Application Details	
Property Description:	Lot: 4 DP: 1119857, 109-129 Kelso Street SINGLETON 2330
Development Description:	Staged construction and staged occupation, of a new two-storey

Development Application 8.2023.502.1 is supported subject to the following conditions being imposed on this application.

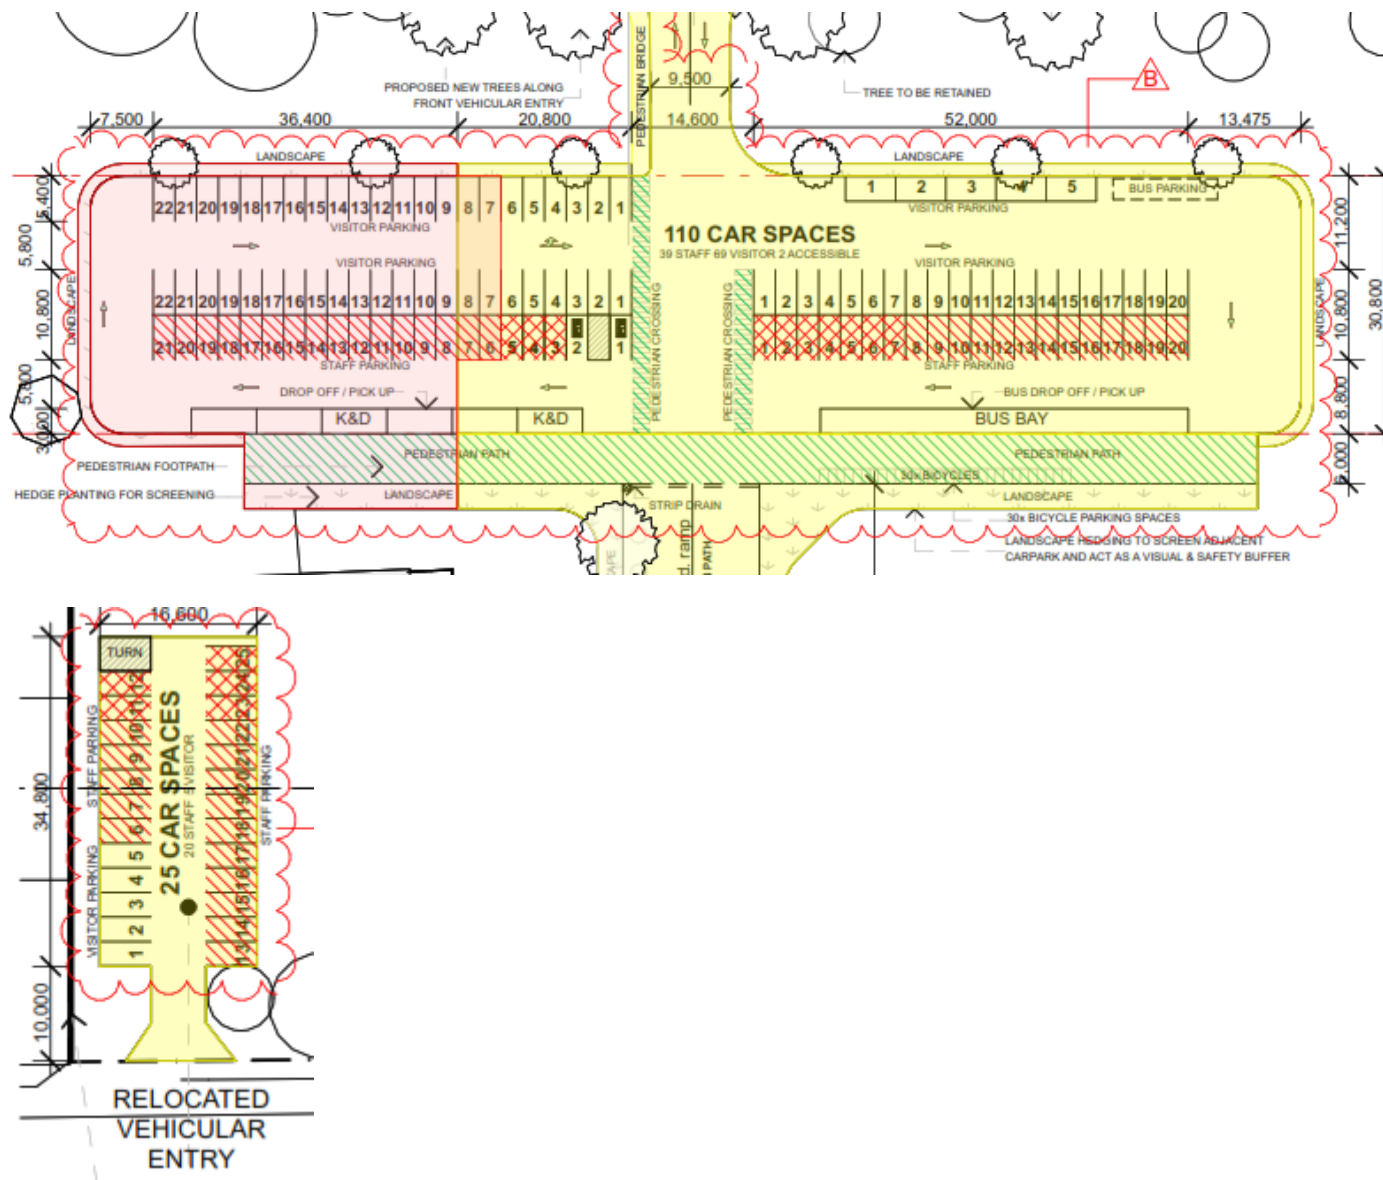
The submitted plans show a total of 135 car parking spaces, which is a shortfall of 8 spaces based on the requirements of the DCP. However, as the childcare center and the school share the same parking area, and given that drop-off and pick-up times for the two facilities will largely occur at different times, the number of spaces provided is considered satisfactory.

Singleton Flood Risk Management Study and Plan – Hazard Categories

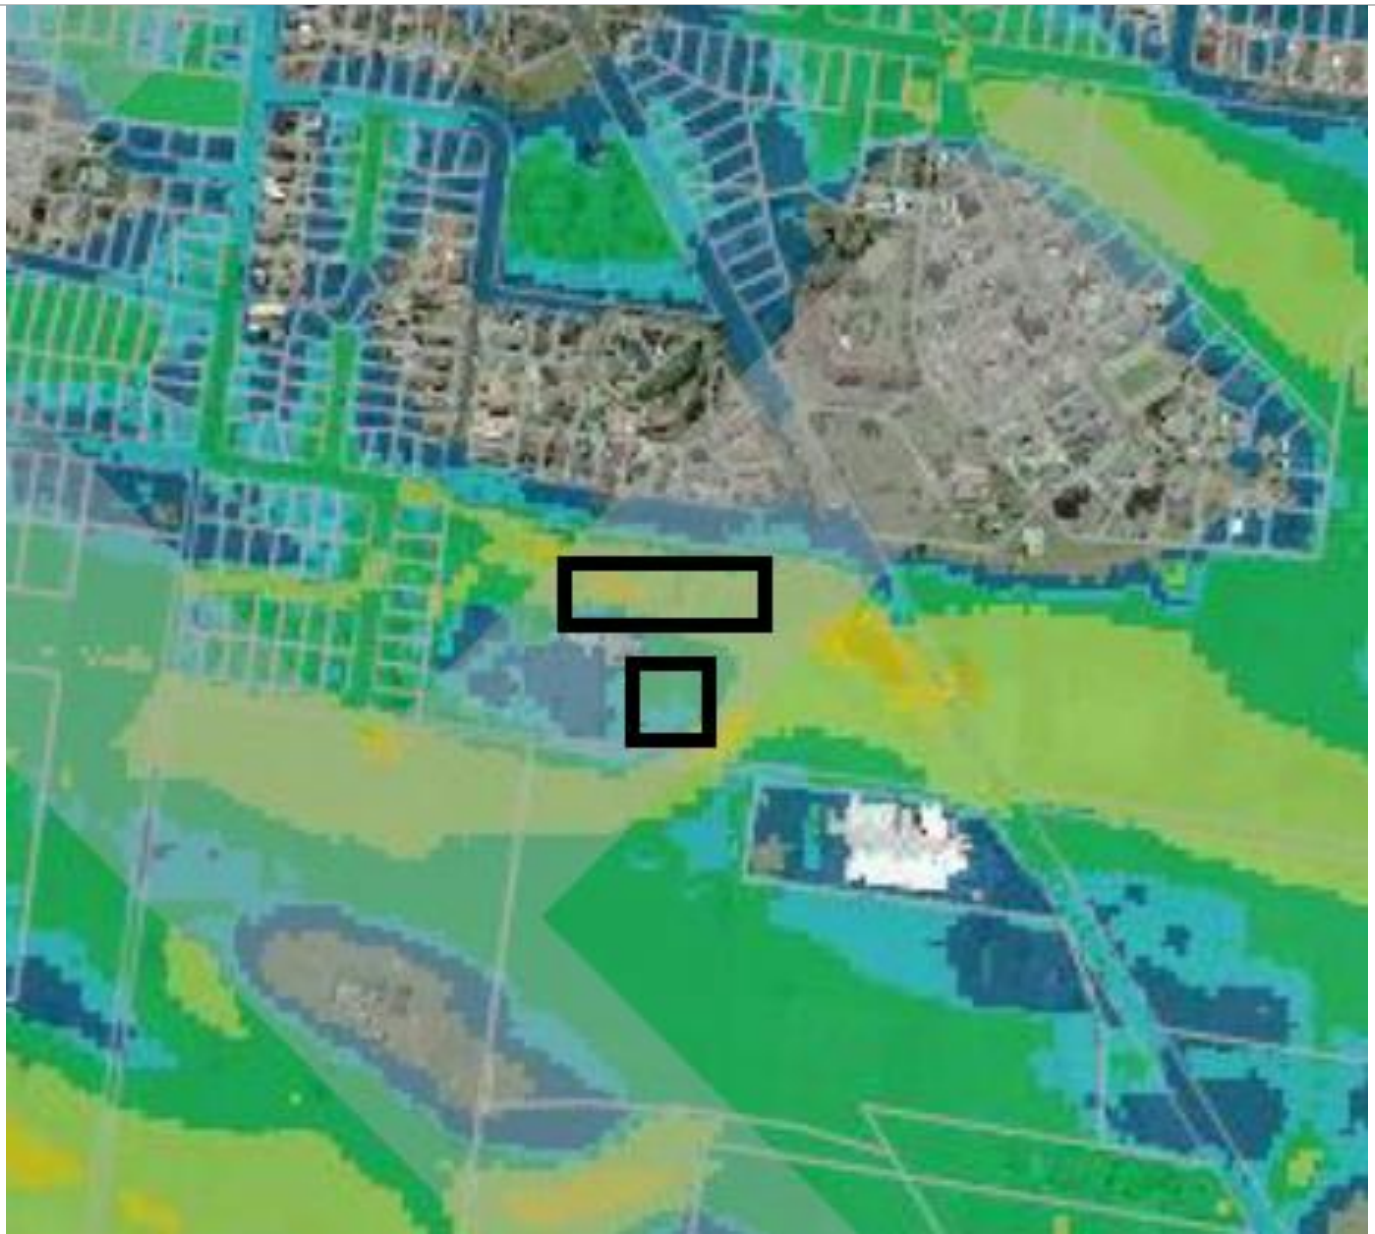
The site is mapped within the Flood Planning area under the LEP flood planning map however, there is no minimum floor height restriction for this site. The Singleton Flood Risk Management Study and Plan indicate that the proposed parking area and building will be outside the H5 and H6 hazard categories. The parking area will be predominantly within a H4 hazard category whilst the building will be within a H2 hazard category. See below:

Figure 4.6 Ground and Finished Floor (FFL) levels for the Baseline and Post-Development Scenarios

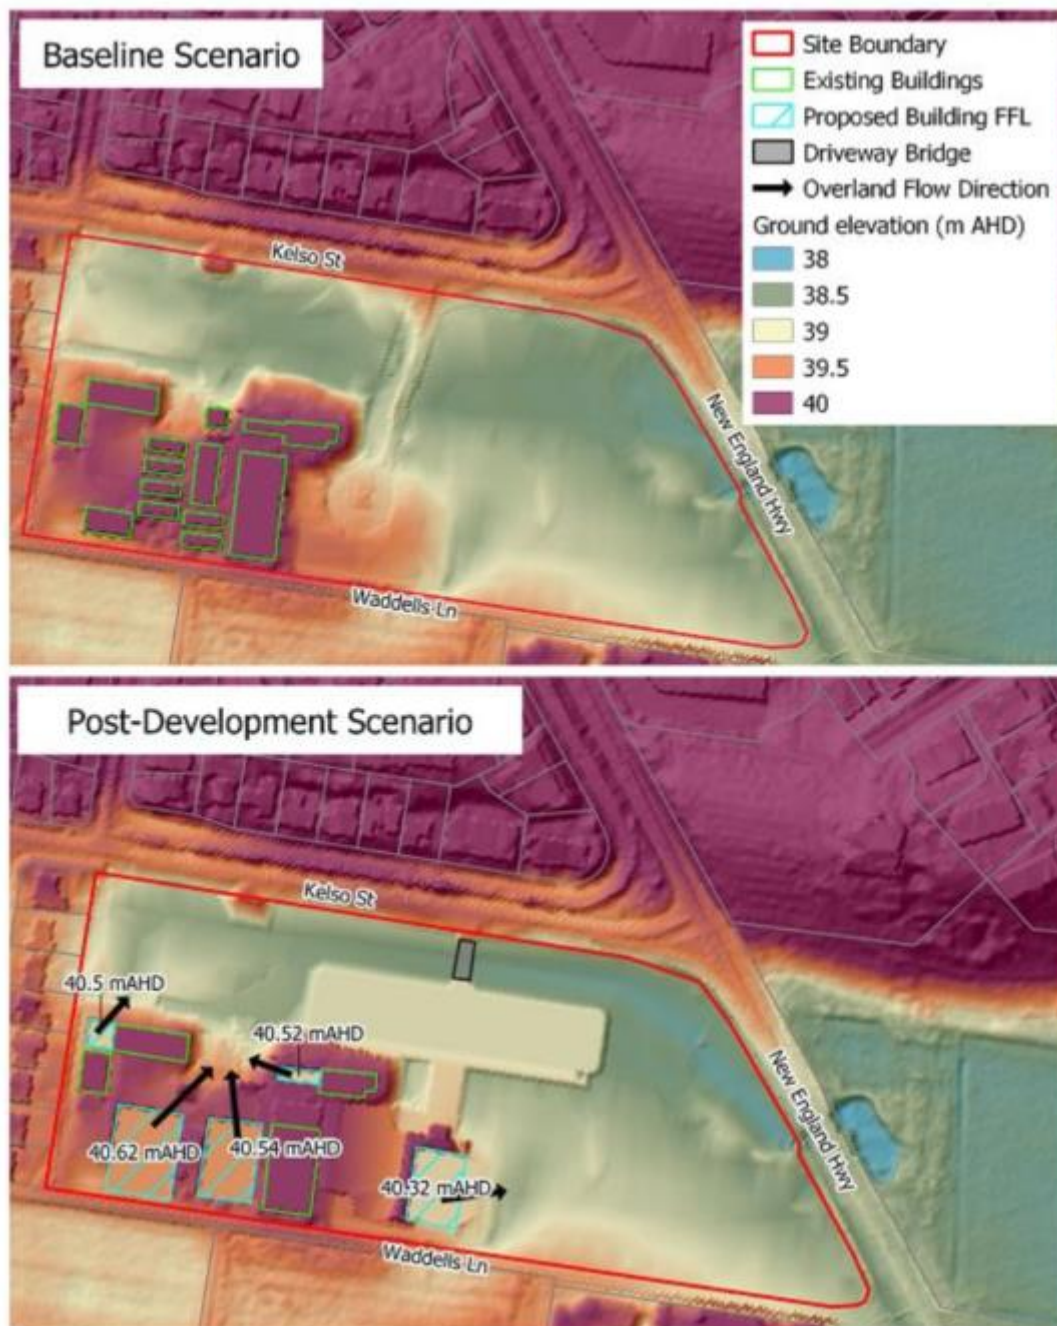
During local flooding, the FIA outlines that open spaces would range between a H2 (unsafe for small vehicles) to a H3 (unsafe for vehicles and children) but would increase to H4 (Unsafe for people and vehicles) during mainstream flooding from the Hunter River in a 1% AEP event. The FIA identifies that the under-croft to the new building would experience H3 and H4 classification from mainstream flooding but concludes that with the proposed new building elevated above the 1% AEP event with 500mm freeboard suitable flood mitigation has been provided.

The Flood Impact Assessments provided illustrate that the development will not cause adverse flood impacts beyond the boundaries of the school and conclude that with the proposed new building elevated above the 1% AEP event with a 500mm freeboard, suitable flood mitigation has been provided. This is acceptable.

Peak Flood Level Impacts (Local Model) - 1% AEP Event

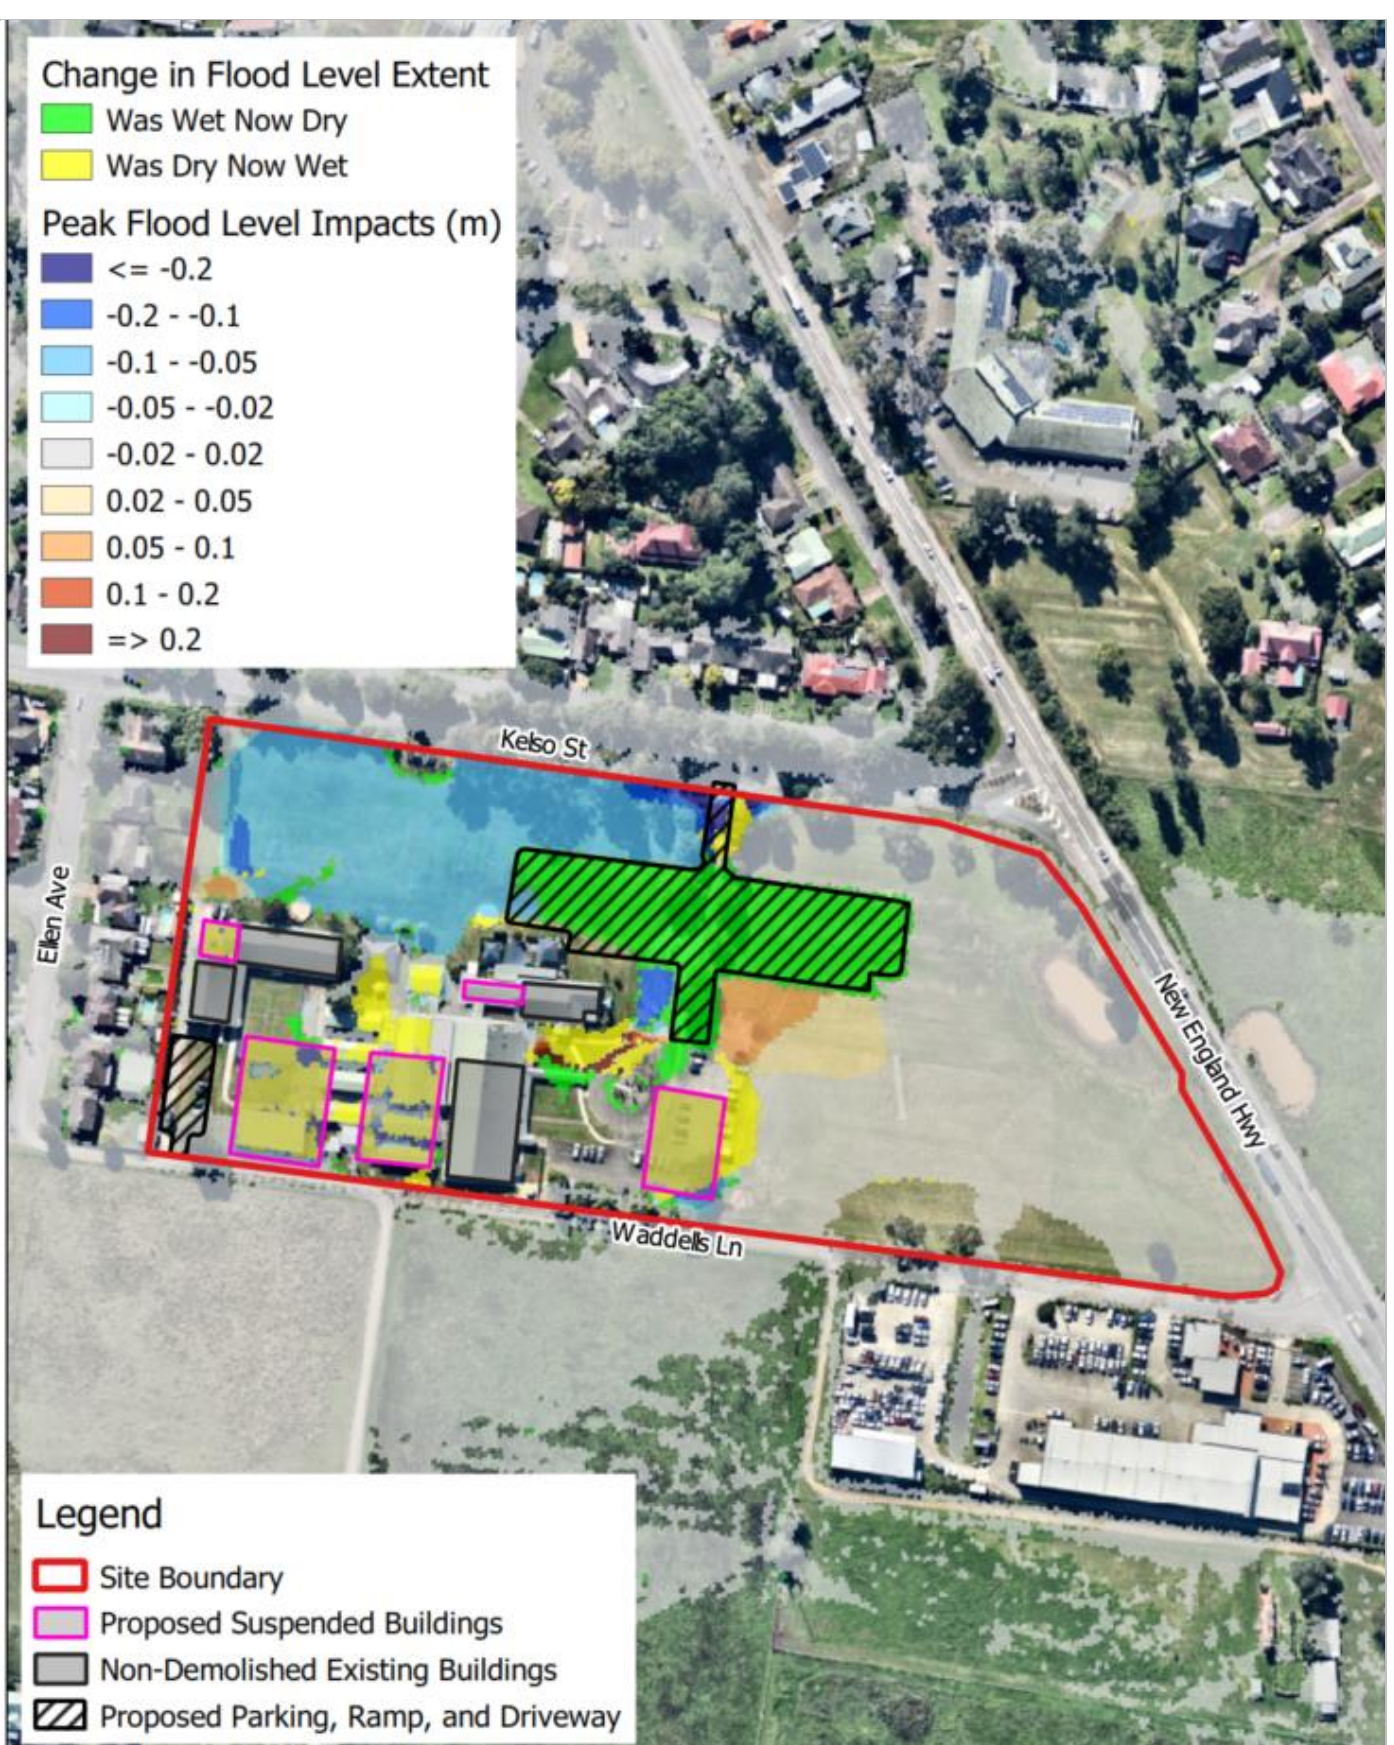
- The applicant should also be informed that, according to the BMT Flood Impact Assessment (FIA), certain areas of the site, particularly the classroom areas, will be adversely affected by flooding due to the proposed alterations. The "Change in Flood Level Extent" models indicate that areas which were previously dry will now be subject to flooding, as shown in both the local and mainstream models. Additionally, the southern carpark is susceptible to flooding at the 1% Annual Exceedance Probability (AEP) level.

Section C (Bridge)

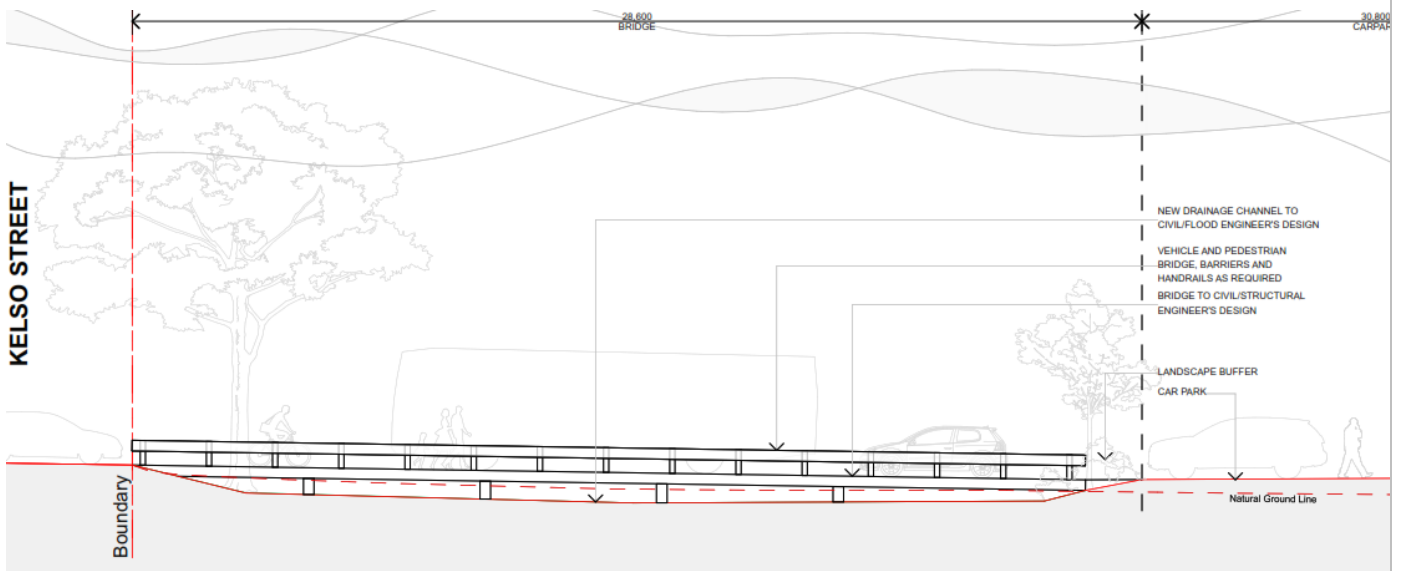
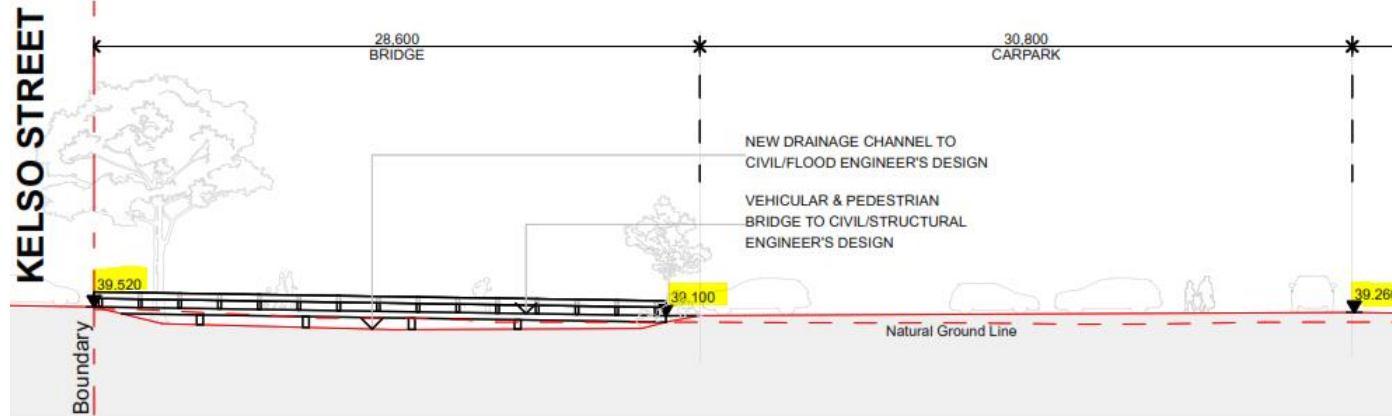
Provisions have been made to manage the anticipated stormwater flow from west to east across the site. This includes the construction of a "bridge" between the northern boundary and the proposed car park, allowing stormwater to flow beneath the access road, in alignment with the existing overland stormwater flow path.
